Comment i-455 (145B.1.4 P 268, L 268)

Figure 145B–11A—PSE implementing CC_DET_SEQ=3, do_cxn_chk result is dual, staggered detection

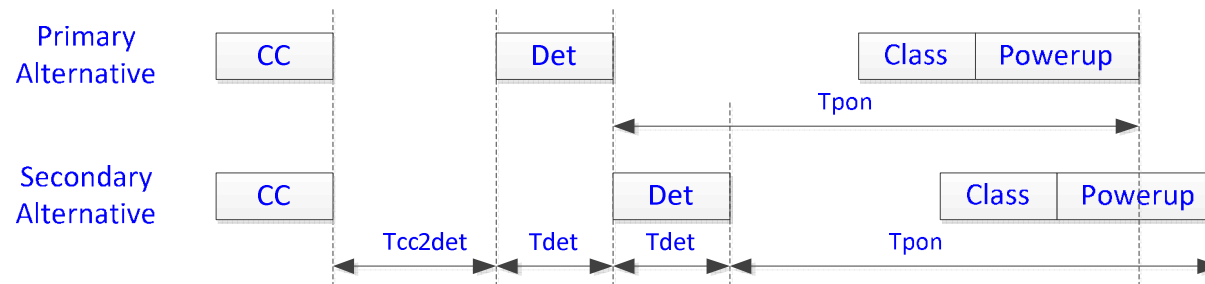
Figure 145B-11 for dual-signature PD shows that CC_DEC_SEQ=3 is only possible when the Detection of the 2nd pairset starts after Tpon +Tx of 1st pairset which is possible but not the only one possible for staggered detection. This create confusion due to lake of clear definitions.

It is possible that specifically for CC_DET_SEQ=3, the intent was to do detection on secondary when primary is on. This is fine but not defined anywhere that this is the intent.

The following definition is more flexible. It allows using class_4PID_mult_events_pri=TRUE and yet turning ON both pairsets together which impossible with the definition in option 1 for dual-signature when using CC_DET_SEQ=3 and class_4PID_mult_events_pri=TRUE (although it is possible by other CC_DET_SEQs).

If the above definitions are acceptable:

Add the following drawing (Figure 145B-11A) after Figure 145B-11.
